CITY OF TEMPE DEVELOPMENT REVIEW COMMISSION

Meeting Date: 12/11/1212 Agenda Item: 2

<u>ACTION</u>: Request approval for a Development Plan Review revision for FARMER STUDIOS, located at 464 S. Farmer Avenue. The applicant is Jason Comer, Architekton.

DPR12217 Development Plan Review building elevation modification.

A.100 FARMER STUDIOS Color Elevations

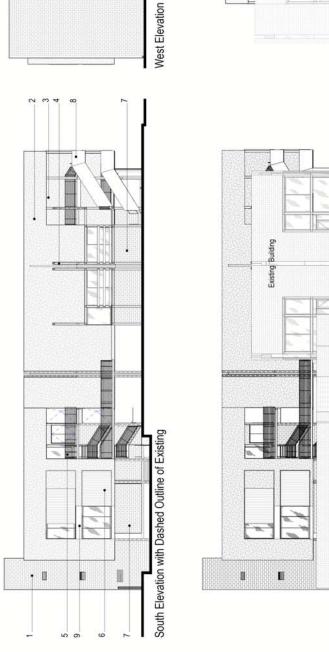
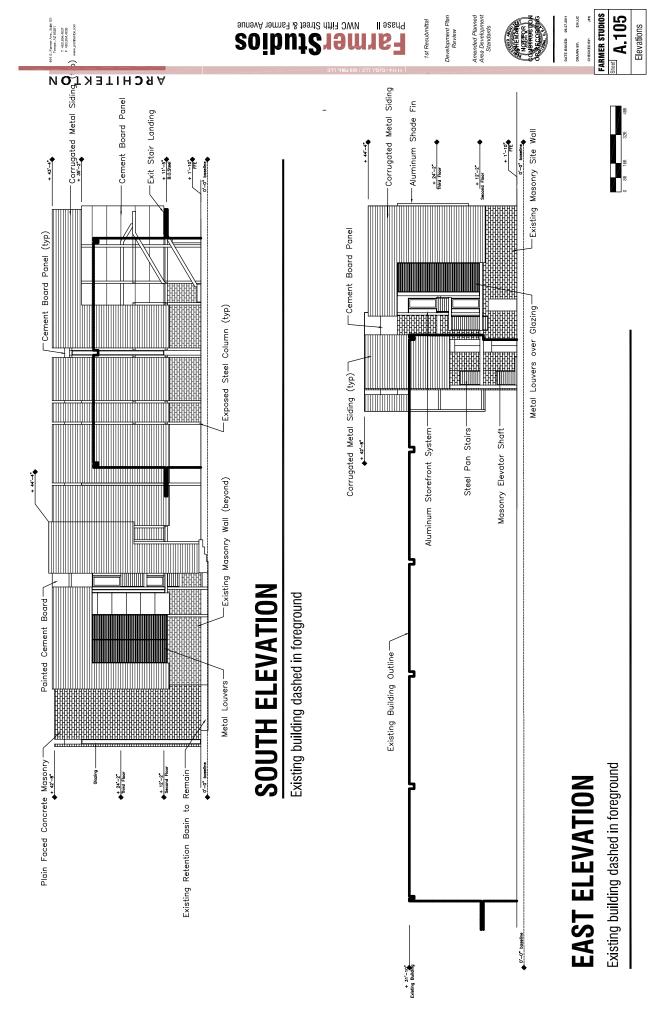
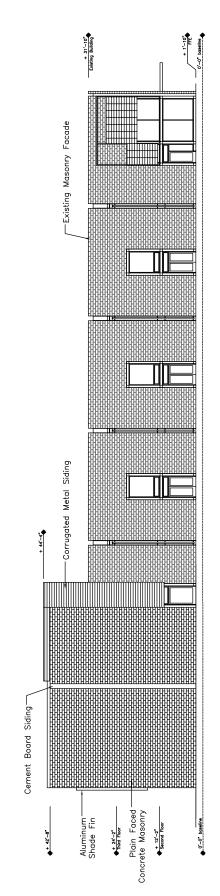
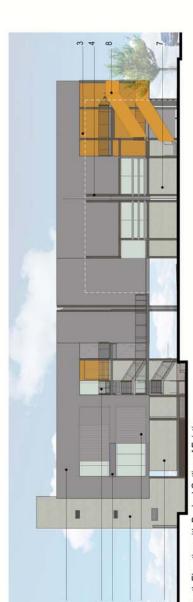
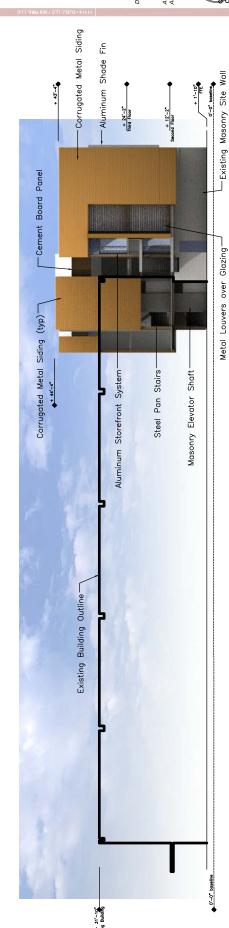
We are seeking to modify the elevations of the proposed building to incorporate operable shade screens that will allow the building's users to better control the amount of daylighting in the interior spaces. The previously approved façade design had a "second skin" of corrugated, perforated metal that was arranged in a segmented pattern of vertical panels with an irregular rhythm of tall, narrow windows. The revised fenestration pattern and the elimination of the outer metal skin will allow us to install moveable exterior shade panels on all perimeter windows. These operable screens, made up of translucent polycarbonate panels framed in a metal track, will form an ever changing rhythm as the individual shades are rolled open or closed.

- The primary building color has been changed from a rusted, corrugated metal finish to a neutral, medium gray. The cement board panels and green stucco have been eliminated. Orange has been introduced at the pedestrian entrance along Farmer Avenue and at portions of the elevator shaft to signify entry and guide visitors into the project. Guard rails on the exit stairs along Farmer are constructed of perforated steel in the same orange color.

- The existing CMU site wall along Farmer Avenue is now clad in zinc panels to form a stronger visual base to the project and form a backdrop for the landscape along the sidewalk.

- Window placement has been redesigned to accommodate operable sliding panels of translucent polycarbonate.
- The parapet height has been lowered except where it screens mechanical equipment in order to enhance the proportions of the elevations. There are no proposed changes to the overall height square footage, or to the development standards.

- 10. The materials and colors are approved as presented:
 - a. Roof flat parapet
 - b. Smooth-faced CMU Grey
 - c. Exposed Structural Steel weathered finish clear sealed
 - d. Zinc Panels VM Zinc, Quartz Zinc Grey

- e. Stucco Smooth Finish Dunn Edwards DE6376 Looking Glass Grey
- f. Stucco Accent Dunn Edwards DEA116 Instant Orange
- g. Perforated Steel Railing Dunn Edwards DEA116 Instant Orange

- h. Provide main colors and materials with a light reflectance value of 75 percent or less. Specific colors and materials exhibited on the materials sample board are approved by planning staff. Additions or modifications may be submitted for review during building plan check process.
